UNITED STATES PATENT AND TRADEMARK OFFICE

Office Action Summary	Application No. 10/764,071	Applicant(s) KEJEJIAN, TOROS	
	Examiner David C. Reese	Art Unit 3677

THIS NON-FINAL ACTION IS RESPONSIVE TO THE AMENDMENT FILED 1/22/2007.

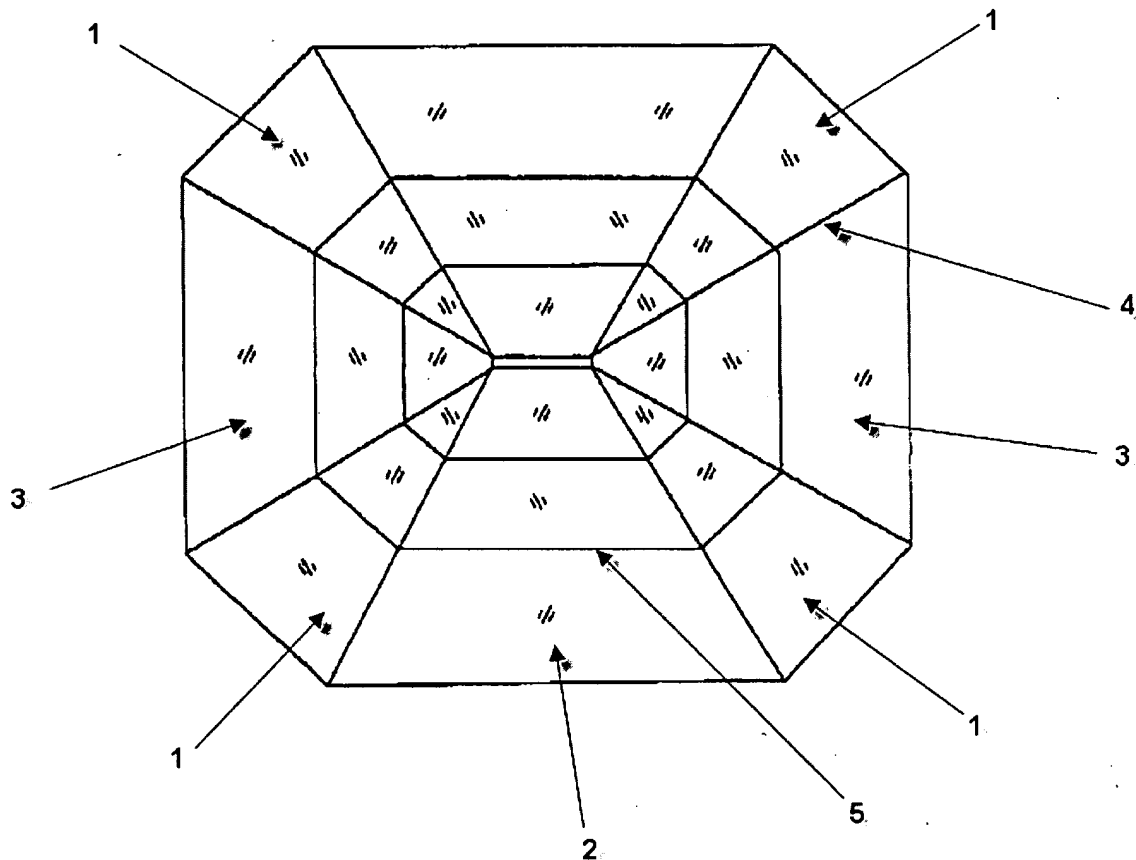
As for Claim 1, Abaev teaches of a mixed cut gemstone comprising:

a pavilion (see figure below);

four lower corner facets (1), said lower corner facets being triangles (1);

two long-side lower girdle facets (2), said long-side lower girdle facets being triangles or trapezoids (2);

two short-side lower girdle facets (3), said short-side lower girdle facets being triangles (3);

a plurality of step cuts (5), said step cuts being substantially equal in width; and

a plurality of rib lines (4);

whereby said steps cuts (5) are cut at a predetermined angle with respect to said lower girdle facets (2,3) with each step (5) being at a slightly different angle, said different angle step cuts (5) [allowing light that passes through the crown to hit the plurality of steps cuts at different angles thereby bending the light several times in different directions thus providing the gemstone with parallel incoming and outgoing rays of light that make the gemstone appear more brilliant and scintillated].

Examiner's note: the above statement in brackets is an example of intended use. Note that it has been held that a recitation with respect to the manner in which a claimed apparatus is intended to be employed does not differentiate the claimed apparatus from a prior art apparatus satisfying the claimed structural limitations. *Ex parte Masham, 2 USPQ2d 1647 (1987)*. In the instant case, the above amendment to the claim has provided no additional structure requirements or limitations. Attempting to claim a gemstone via the way light passes through said gemstone is not proper and is not given any patentable weight over the prior art that satisfies the same structural limitations.
